CITY OF ALBUQUERQUE

December 22, 2017

**RE: Heritage Marketplace Tract A2 (Burger King)
7900 Ladera Dr NW
Grading and Drainage Plan
Engineer's Stamp Date 12/19/17 (File: H09D024A)**

ENGINEER'S SEAL	Title: BURGER KING 7900 LADERA DRIVE NW GRADING AND DRAINAGE PLAN	DRAWN BY
		DATE
12-18-17	RHD Engineering, LLC 4305 Purple Sage Ave. NW ALBUQUERQUE, NM 87120 (505) 288-1621	SHEET # 1 of 2
Richard Dourte P.E. #10854		JOB #

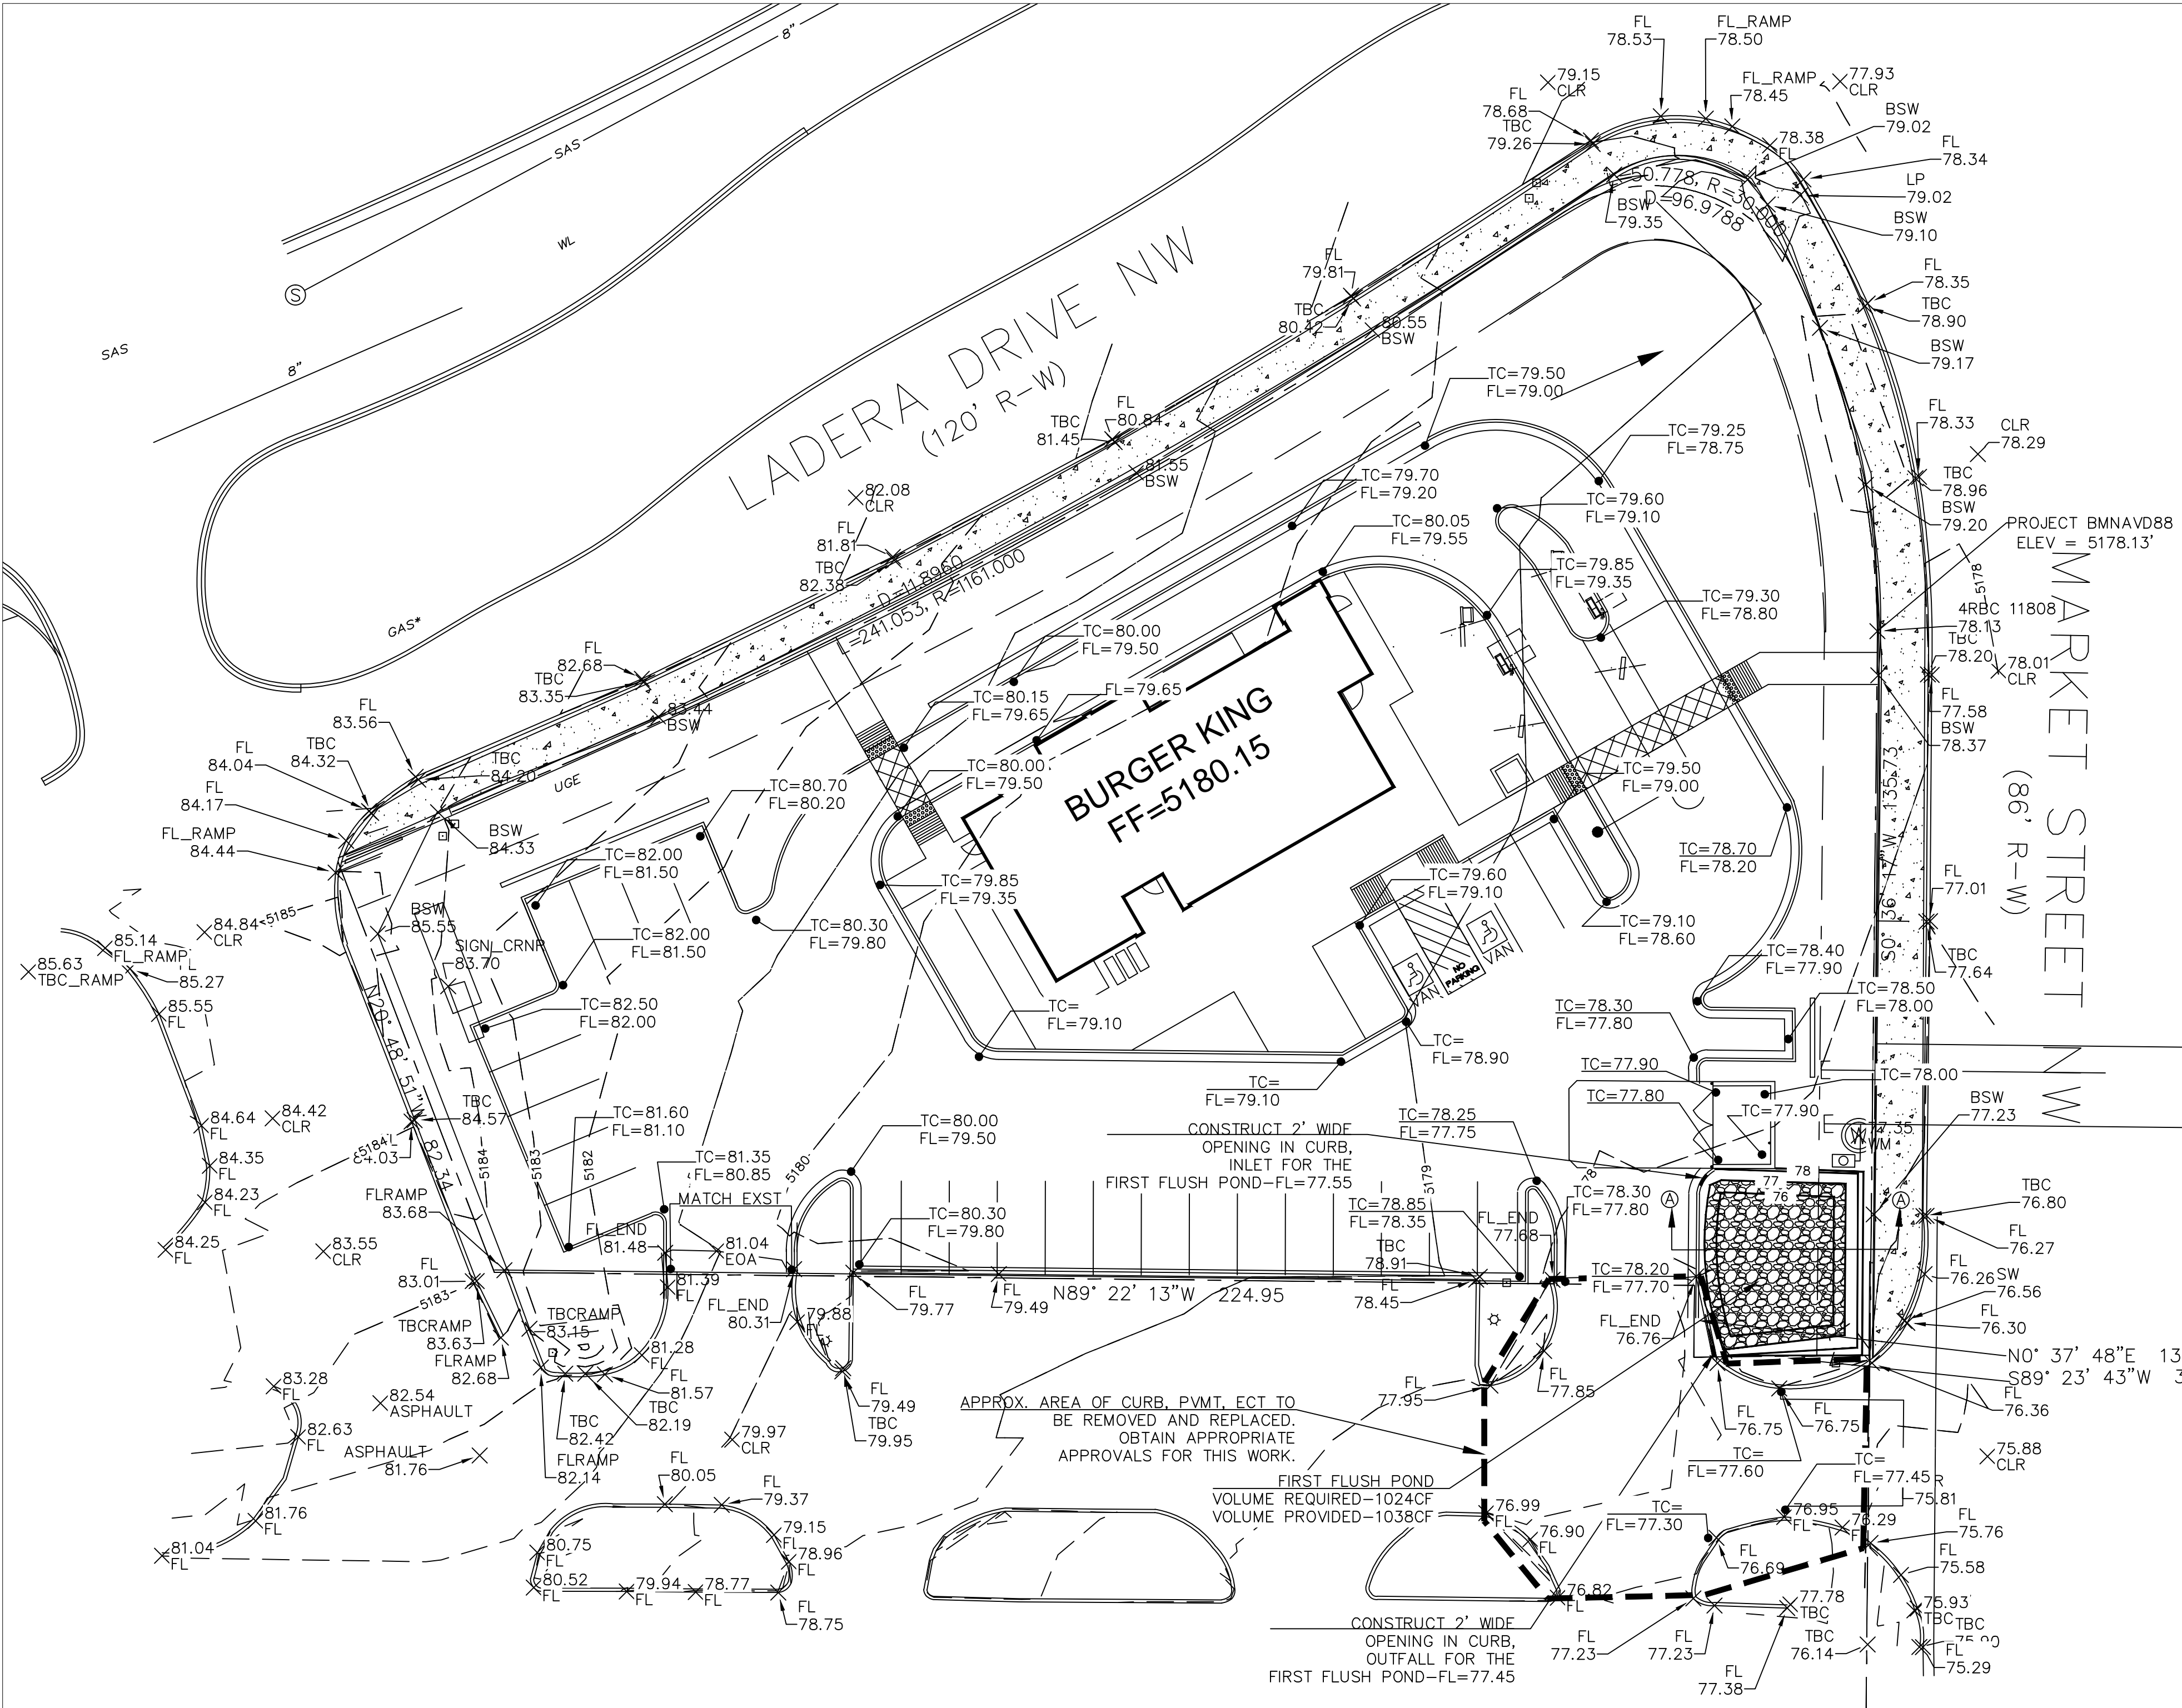
1. The Grading and Drainage Plan will need to be clearly labeled as "Conceptual, not for construction" for inclusion in the Site Plan.
2. Include a narrative describing how this plan of development is in compliance with the approved Heritage Marketplace Drainage Report (H09D024).
3. The dumpster area should be contained, plumbed through a grease trap, and into the sanitary sewer. Include the utility plan if this information is located there. You may also want to raise the dumpster pad elevation to keep storm water from entering the dumpster area.
4. Please provide written permission from the adjoining property (Walmart) for work on their property.

5. A detailed grading and drainage plan, with the "conceptual" markings removed will be required for Building Permit.
6. It is unclear that storm water will be forced into the pond at the curb cut. Please include a clearly defined waterblock at the SE property line/drive entrance that will force flows into the pond instead of allowing them into the Walmart parking lot.
